T-13524

**BEFORE THE WATER RESOURCES DEPARTMENT
OF THE
STATE OF OREGON**

In the Matter of Special Order Volume)
120, Pages 83-88 approving T-13524, Lake)
County)

CORRECTING ORDER

Groundwater Transfer Application T-13524 (Temporary) JR Simplot Properties III, LLP (To Wells)

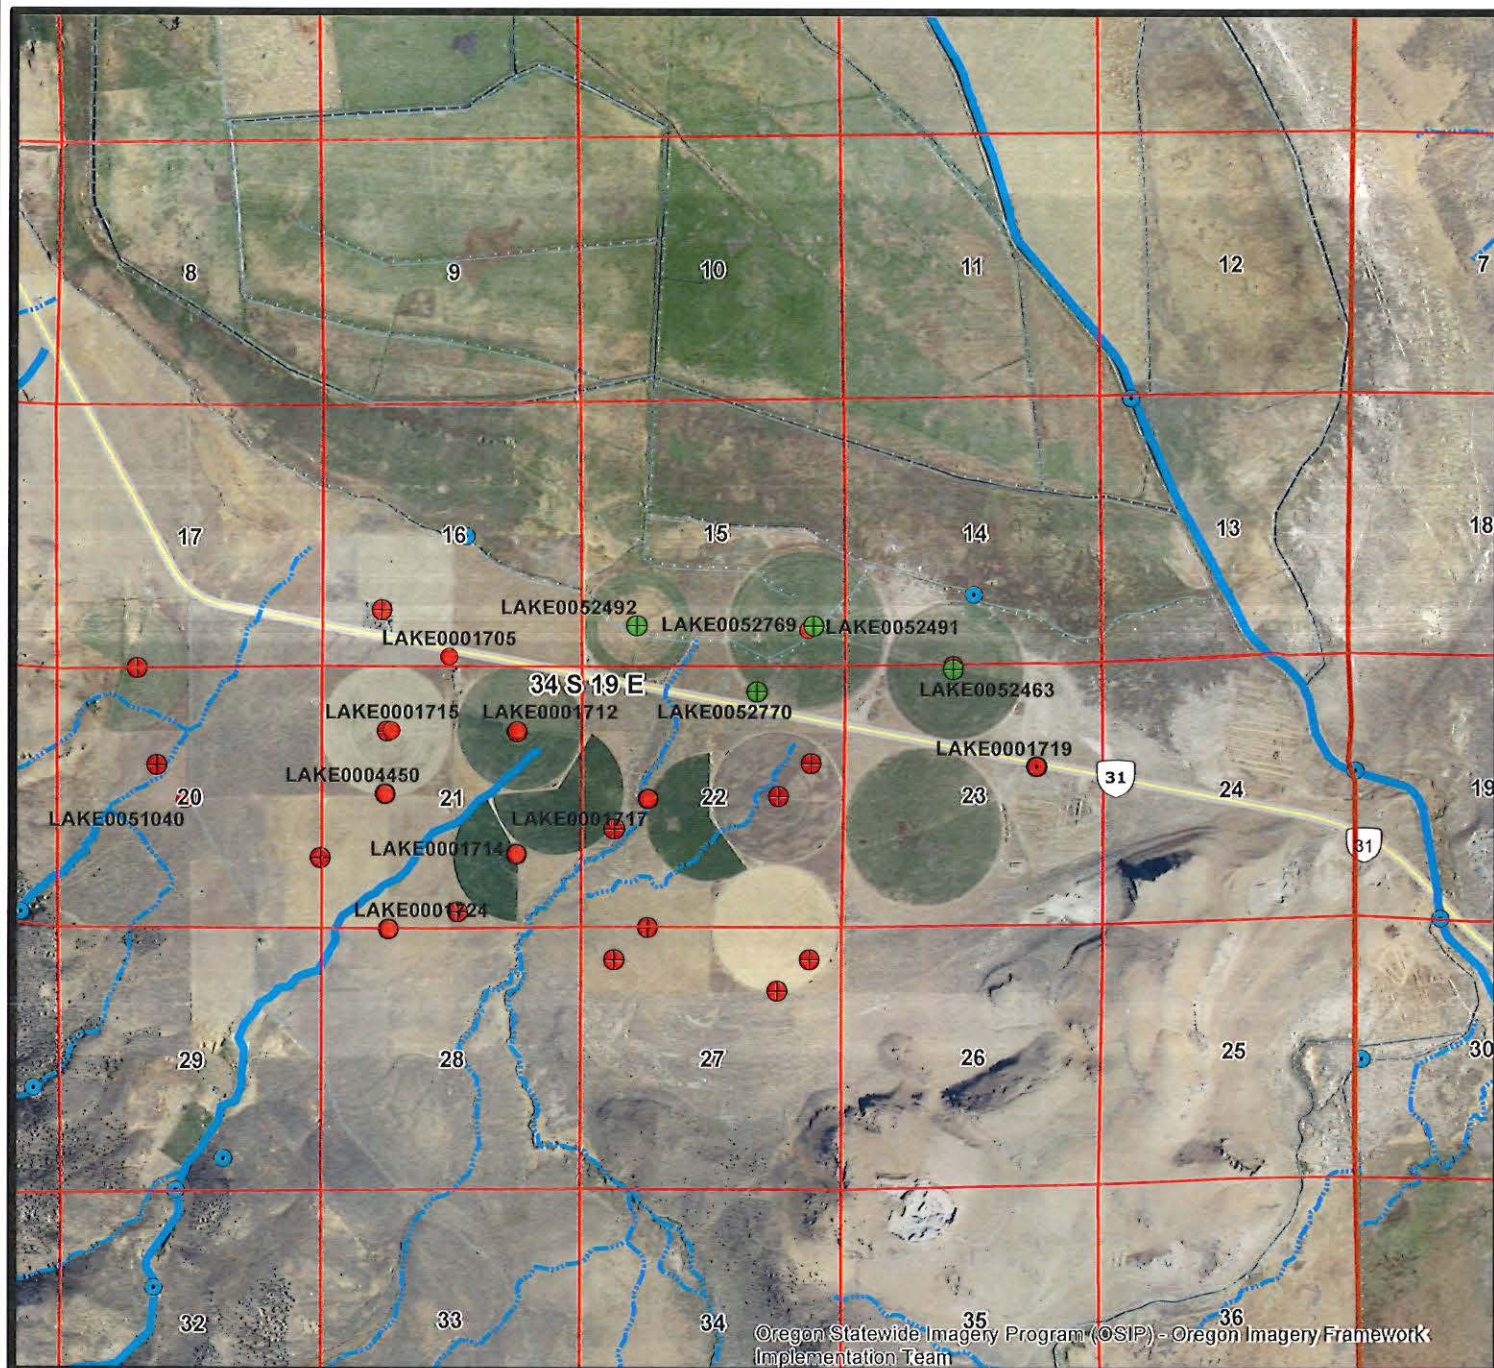
This proposed POA change is less protective of shallower wells and surface water. To be similar to the "From" wells, the "To" wells should ideally obtain 75% or more groundwater from the deeper predominantly volcanic rock and sediment unit.

Yes. The proposed change will move groundwater pumping about 6.8 to 8.8 mile south from the north side of Upper Chewaucan Marsh to the south side of Upper Chewaucan Marsh (see attached maps). The proposed change will move groundwater pumping closer to a different set of groundwater right wells (see attached maps).

Additionally, the proposed change moves groundwater pumping into a vicinity that may be experiencing a groundwater level decline since 2005 (see attached hydrographs for well LAKE 1719 [417-feet total depth]: data from all seasons and data from winter-spring only). The hydrograph for well LAKE 1719 showing data from winter-spring only shows relatively stable groundwater levels near 4302 feet elevation amsl from 1960 to the mid-1970s, a decline of about 5.5 feet from the mid-1970s to early 1980s to a new equilibrium of about 4297 feet elevation amsl that is close to the Chewaucan River stage near the Narrows (relatively steady from about 1980 to 2005), and an ongoing decline since 2005 of about 0.58 feet per year, possibly taking the groundwater level below the river bottom. The groundwater level decline in the 1970s and after 2010 appears to correspond to increased groundwater development in the area.

Condition 7P (well tag condition) for all the "To" and "From" POA wells.

Condition 7T (modified) for both the proposed "To" wells: "Prior to use, the proposed "To" wells shall be configured to allow a strictly clean water (no oil) static water level measurements with an electric-tape. That can include measurement access via an unobstructed vertical discharge pipe that allows the groundwater level to fluctuate freely within the discharge pipe (no valves, etc.). Otherwise, a dedicated measuring tube must be installed prior to use. The tube must be unobstructed, have a diameter of ¾ inch (0.75 inch) or greater, and pursuant to figure 200-5 in OAR 690-200."

Require continuous 1-hour groundwater level measurements via maintained recorder equipment and annual March hand measurements at wells LAKE 52769 and LAKE 52770. Recorder and hand measurement are to be submitted annually to OWRD within 30 days of the March hand measurement.
